**IN THE UNITED STATES PATENT AND TRADEMARK OFFICE**

Applicant(s): BARLEV, Tuvia et al. Examiner:  
Serial No.: 09/510,550 Group Art Unit: 2634  
Filed: February 22, 2000  
Title: HIGH SPEED ACCESS SYSTEM OVER COPPER CABLE PLANT

**PETITION TO WITHDRAW HOLDING  
OF ABANDONMENT UNDER 37 CFR 1.181(a)**

FIG. 5

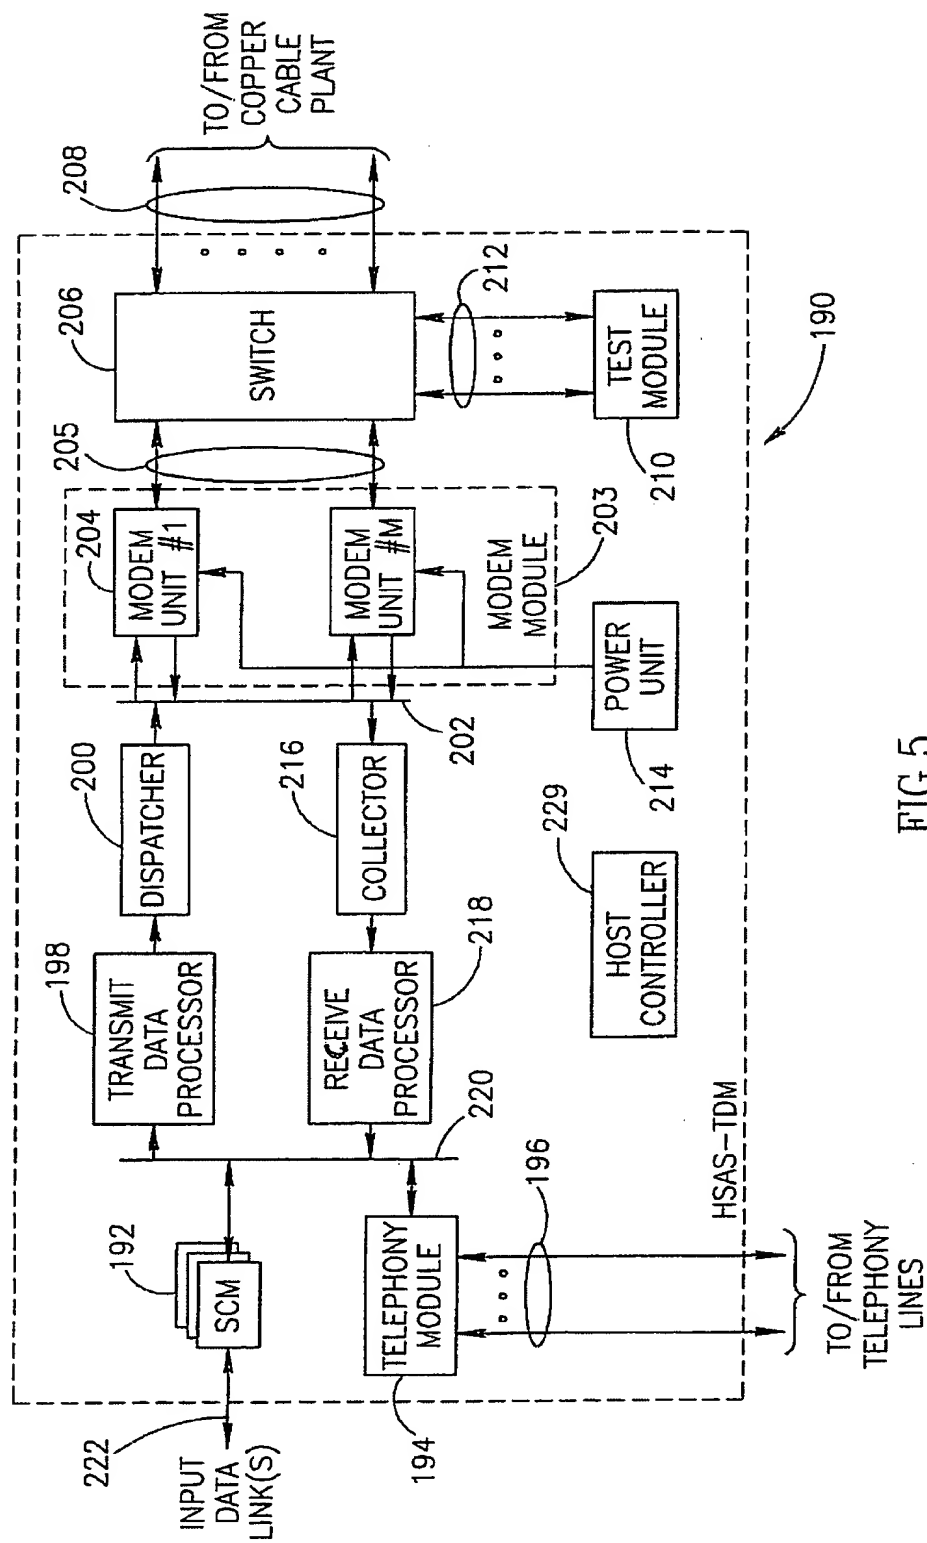
2. The drawings are objected to because in Figures 5 and 6, "REVEIVE" should be "RECEIVE" and in Figure 6, "TEST MODULE 256" should be "POWER SWITCH MODULE 256" in order to be consistent with page 27, lines 14, 19 and 27. A proposed drawing correction or corrected drawings are required in reply to the Office action to avoid abandonment of the application. The objection to the drawings will not be held in abeyance.

In Figure 5, in block 218, the text label "REVEIVE DATA PROCESSOR" was replaced with the text label "RECEIVE DATA PROCESSOR".

Figs. 5 and 6 have been amended to match the specification. The drawing sheets containing each corrected drawing are enclosed for review by the Examiner.
